572-574 Lonsdale Street and 248-250 and 256-260 King Street, MELBOURNE

Planning Permit Application No. PA1900742

Officer Assessment Report Development Approvals & Design

Figures 4 and 5: Indicative plans 26 April 2021 (Source: Applicant)

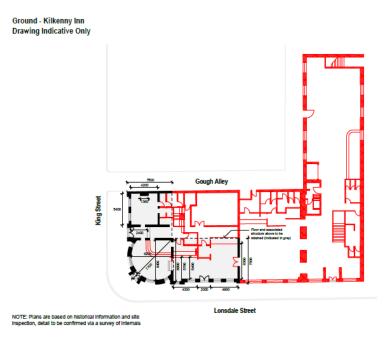
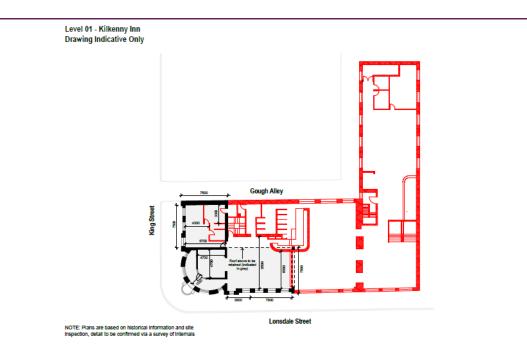
- 65. The Kilkenny Inn building is affected by site-specific Heritage Overlay 679 (248-250 King Street, Melbourne) and is identified as significant. The decision plans include the retention of the street facades, external side walls to a depth of 7 metres and part of the roof.
- 66. In response to concerns raised by the Department and the council, the applicant provided indicative plans dated 26 April 2021 for discussion with a revised extent of demolition based on historical information and a site inspection. The plans indicate the retention of rooms and internal walls fronting the corner and King Street (refer Figures 4 and 5).

67. The indicative plans seek for the retention of the three dimensional form of the front or principal part of the Kilkenny Inn building, being the first room in depth. Clause 22.04, Heritage Places in the Capital City Zone expectation is that the full demolition of significant buildings will not generally be permitted. This extent of demolition, together with the recommended conditions from the council, is supported and provides greater compliance with Clause 22.04.

Figure 10: Heritage setbacks (Source: Applicant)

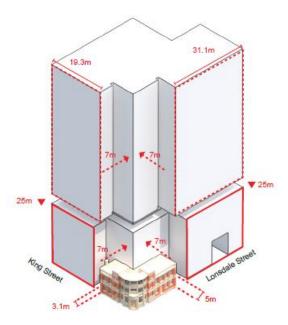
- 68. The new building is also considered to be acceptable with regard to policy for additions at Clause 22.04. In particular, it is acknowledged that the design has evolved from application lodgement on 19 December 2019 with a tower overhang to the decision and indicative plans with the removal of the overhang and the abovementioned 7 metres setback above the retained Kilkenny Inn building. The proposed 7 metres setback together with articulation measures including the notional podium and respectful palate of materials and finishes will respond to the details and prominence of the retained heritage building. An assessment of the height, setbacks and building form against DDO10 built form controls is discussed in the following section of the report.

Figure 14: Setback from Manton Lane at level 10 (Source: Application)

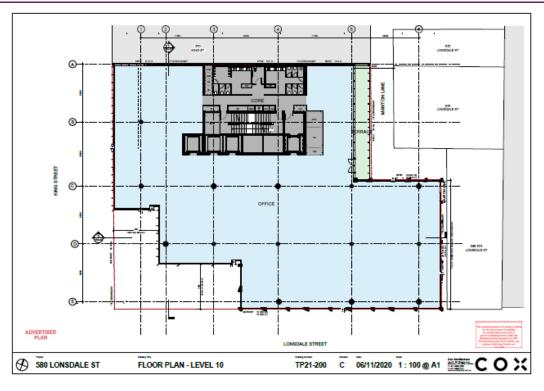
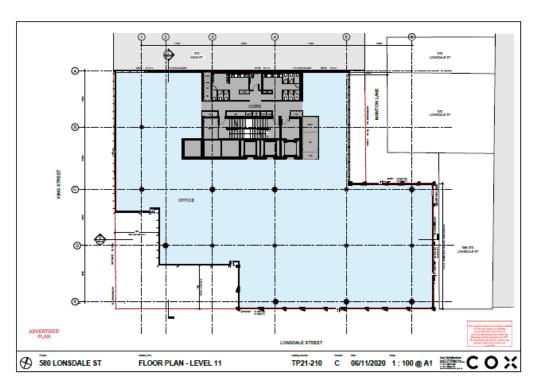
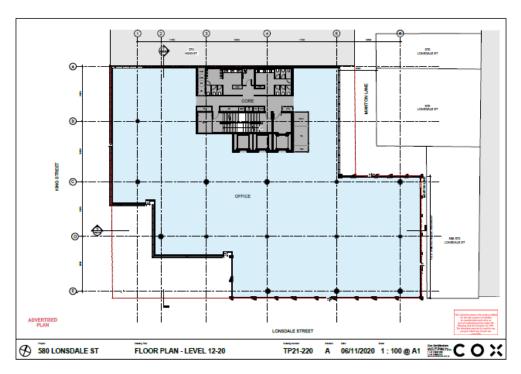
- existing building on an adjoining site is built to that boundary. 272-274 King Street is built to that boundary.
- Above the 10 storey street wall to Manton Lane (56.18 metres AHD or approximately 39 metres), the built form is setback 6 metres from the east side of Manton Lane or 570 Lonsdale Street. Based on a laneway width of approximately 4 metres, this equates to 4 metres from the centre line of Manton Lane. To comply with the modified requirement, it is recommended that above 40 metres this setback be increased to 5 metres from the centre line of Manton Lane. This is reflected in the conditions agreed between the council and applicant post the FMC meeting dated 18 May 2021.

- Overshadowing and wind impacts will be discussed later in the report.
- Reasonable provision is made for sunlight, daylight, privacy and outlook, given the surrounding street network and land uses.
- There are no direct sensitive abuttals with 272-274 King Street presenting as a blank wall to the shared boundary and no habitable rooms at 570 Lonsdale Street on the opposite side of Manton Lane. Therefore, there is no direct overlooking impacts.
- The proposed articulation, recesses and varied façade materials will ensure that the building will not appear as a continuous wall.
- Heritage considerations are discussed earlier in the report.

Figure 19: Render of the corner of Lonsdale Street and King Street (Source: Application)

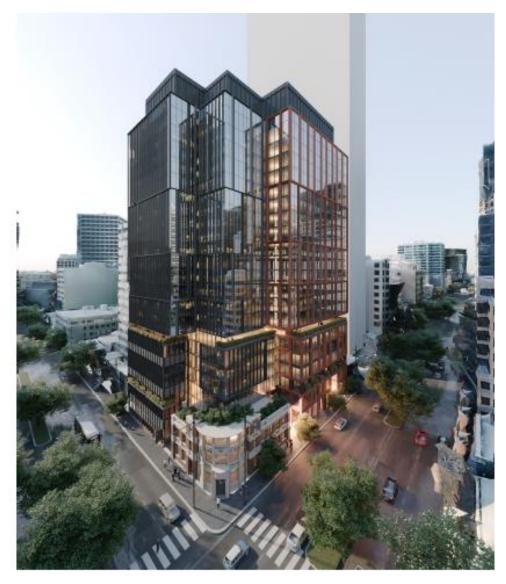
- 80. The council has recommended a condition requiring a façade strategy including further details of materials and finishes. The condition is supported to ensure that the proposal achieves the façade treatment presented in the submitted renders.

Figure 20: Ground Floor Plan (Source: Application)

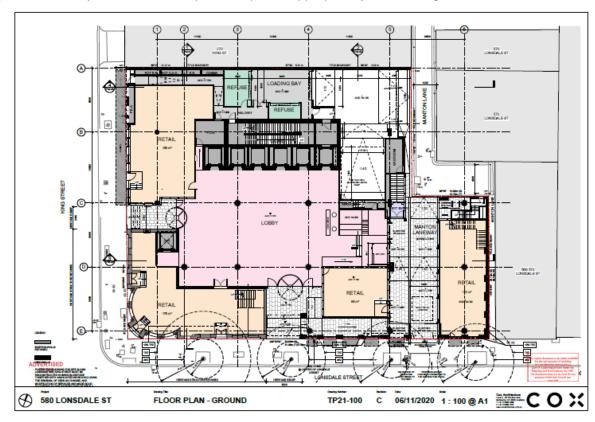
- 83. With regard to Lonsdale Street, a DDA path is proposed between the office lobby entry and Manton Lane. It is located between the vertical grid brickwork façade and a retail premises. The council has raised concerns regarding this section of 'false façade' and recommended opening this interface as a

- colonnade. This recommendation and the resulting permit conditions are supported to encourage use of the DDA path.
- 84. The car park and loading bay entries are combined via Manton Lane allowing the removal of an existing crossover to King Street. This has allowed for the abovementioned recess providing pedestrian entry to the office lobby and responds appropriately to the design intent of DDO3.

Figure 3: Indicative plans 20 April 2021 (Source: Applicant)

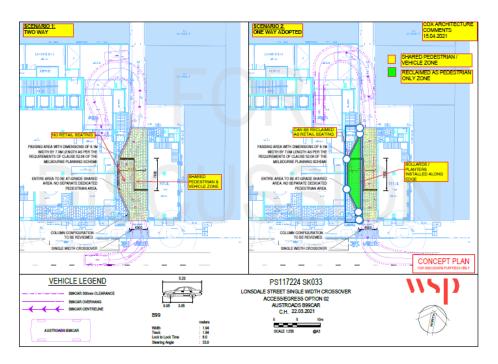
- 110. In response to objector concerns, the applicant provided indicative plans dated 20 April 2021 for discussion with a revised vehicle access plan from one-way to two-way off Lonsdale Street. The plans also indicate a future scenario whereby the widened accessway from Lonsdale Street could be reclaimed as pedestrian / retail space should Manton Lane be made one-way in the future (refer Figure 3).

111. The council supports the revised arrangement in the indicative plans subject to a double vehicle crossover on Lonsdale Street and the proposed installation of bollards on Manton Lane being replaced with alternative traffic measures. This position is supported and can be achieved with conditions on any permit to issue. In addition, the adaptability of the design is commended in terms of the future scenario should Manton Lane be made one-way in the future.
